**ADDENDUM NO. ONE**

January 9, 2017

**Sanctuary & Classroom Addition  
THE CARPENTER'S CHRISTIAN CHURCH  
Harrodsburg, Kentucky**

Re: Addendum No.1  
The Carpenter's Christian Church  
Harrodsburg, KY  
BK Project No: 16069.01

A-5

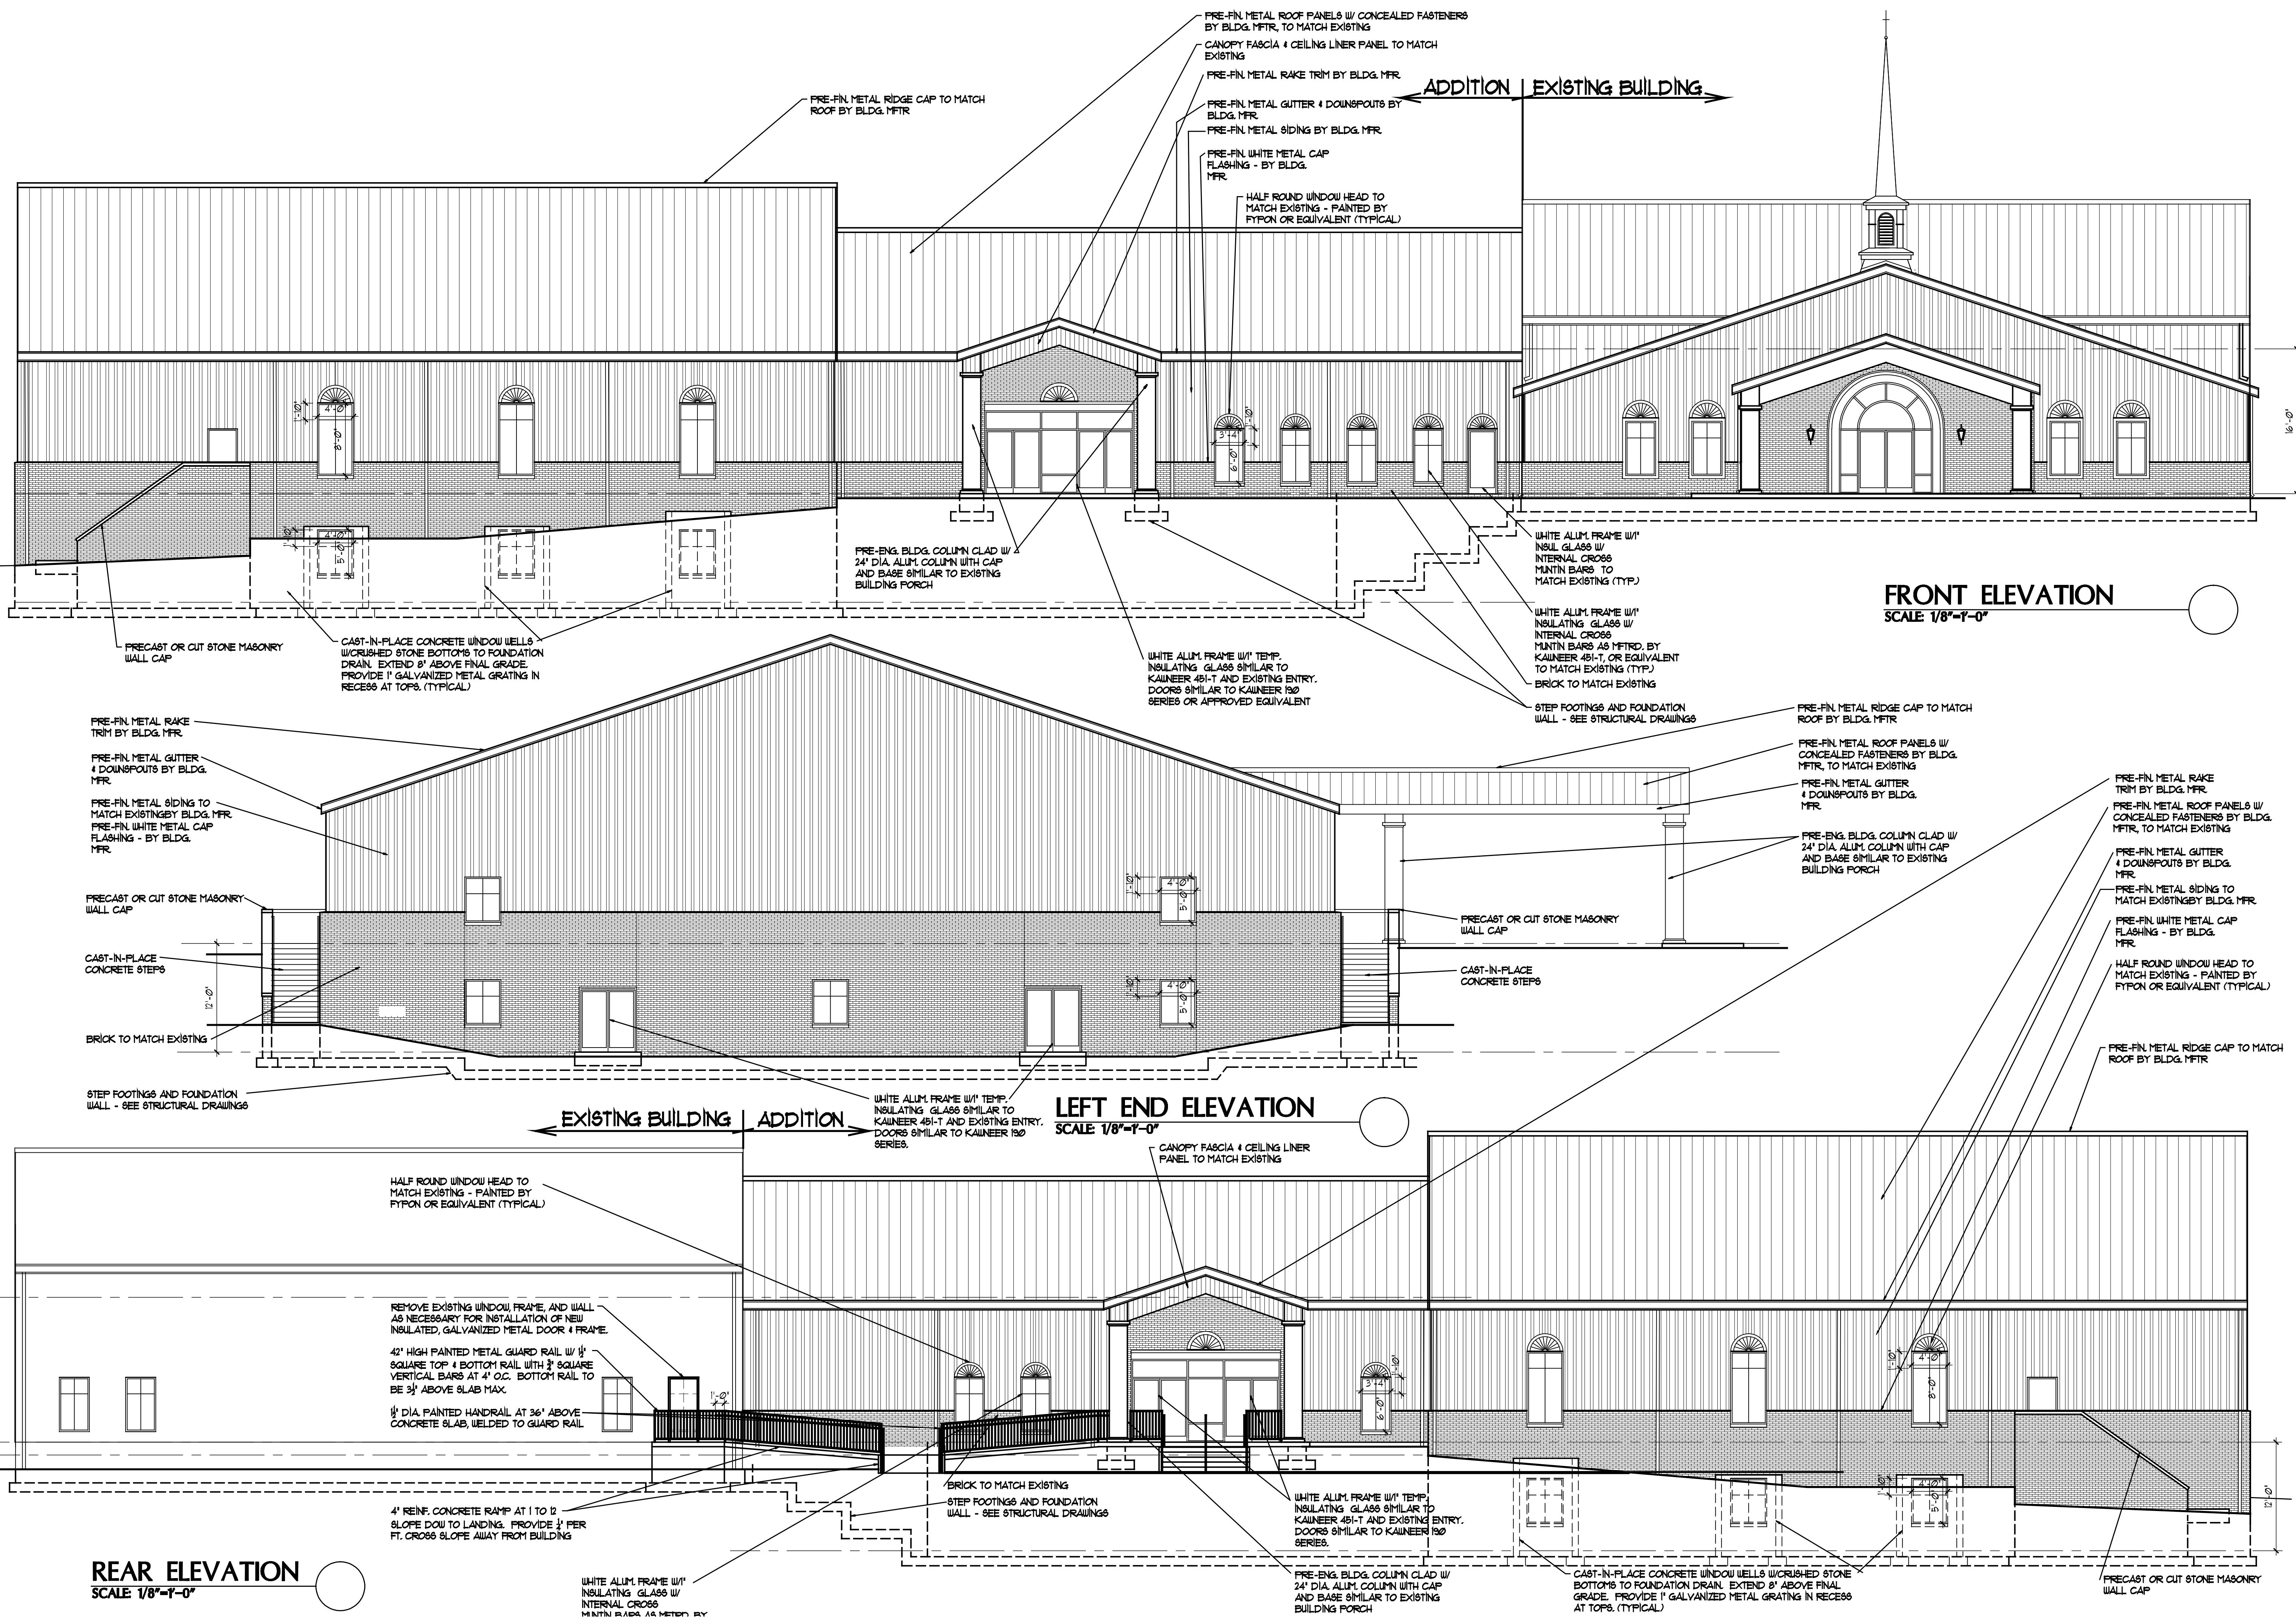
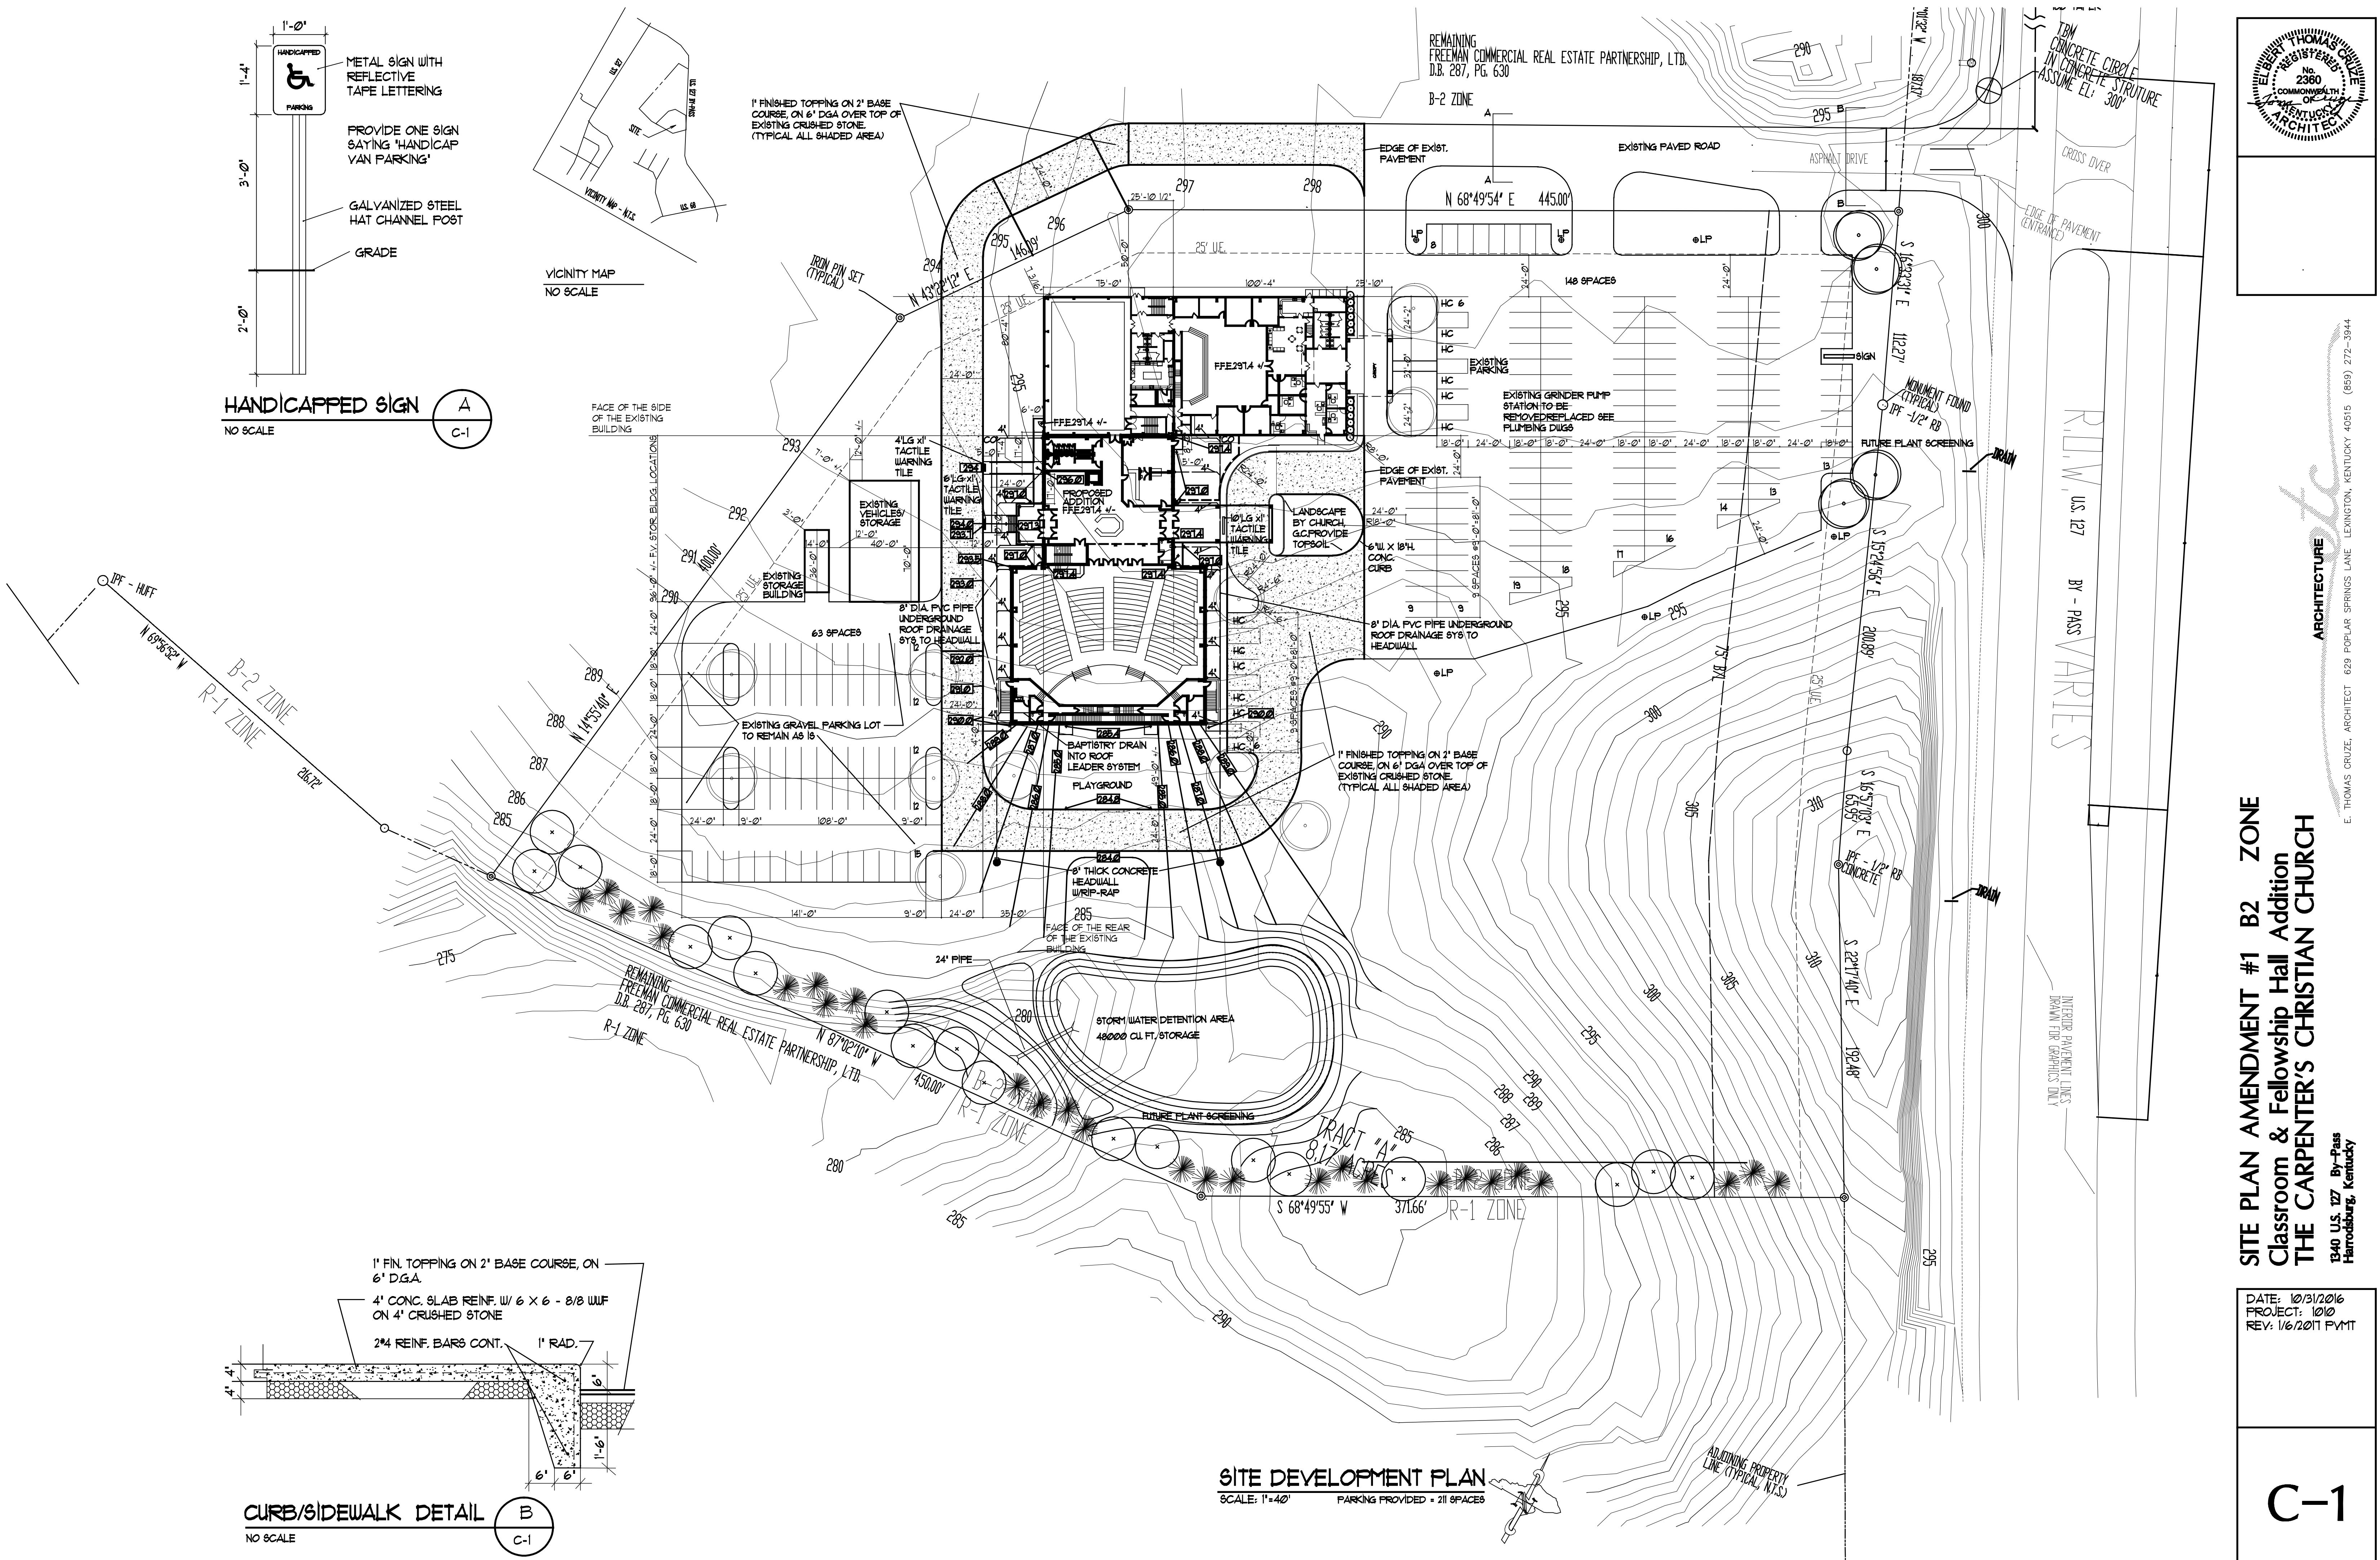
18. Regarding painting of the exposed structure: Paint any exposed structure on drawing A-2, in the Worship Area and Foyer to match the "Simple-Saver" type insulation. On drawing A-1, Paint black exposed structure and wall areas, from the bottom of the beam flanges up to the underside of the floor deck in the "Children's Worship Area", such that a straight line from the bottom of the lowest beam flange to the underside of the floor deck above is all black.
